Stephen Gartland Glendale Leixlip (zone E)

4.60.2 Response to submission 1.

ABP- 314232-22

*Google map view
of COPE BRIDGE*

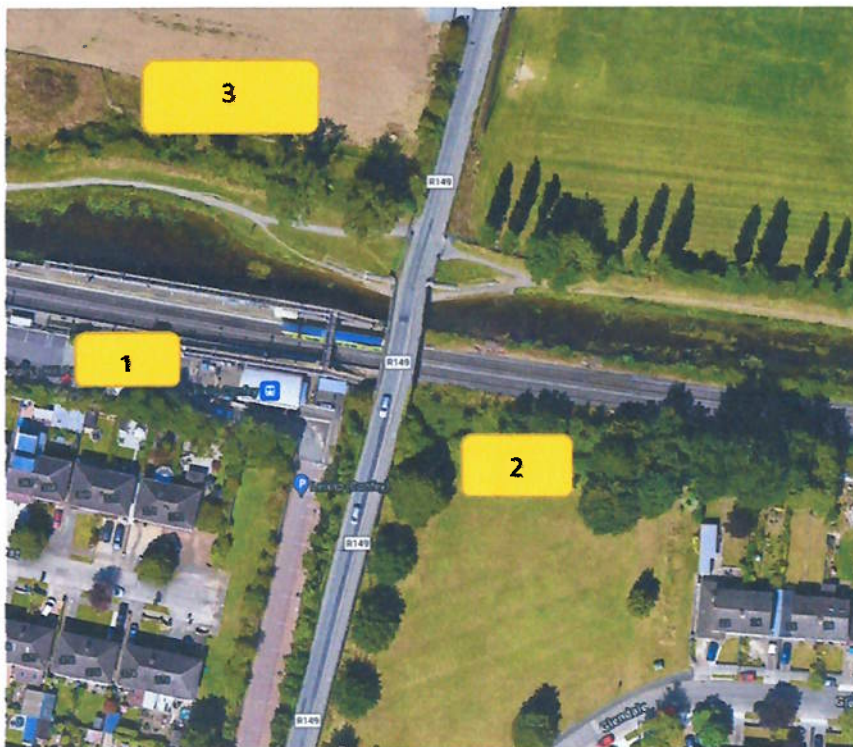
1. There was no Public Consultation we met with CIE on our green area in June 2022 to inform us of their plans for the bridge and substation
2. The 2 options that were considered in section 3.6.1.5.9.1 Chapter 3 should be reviewed and a 3rd option be considered. We would ask that the area north of the train station across the rail line and canal be considered. This undeveloped land has been used over the last 5 year as a depot compound for companies laying the new sewage from Intel to the Leixlip water treatment plant. We think that this should be strongly considered for the substation and compound as some the lands could at a later date be used as a car park and with consultations with Kildare County Council's LAP.

Cope Bridge Confey Leixlip Option 3 for Leixlip Substation
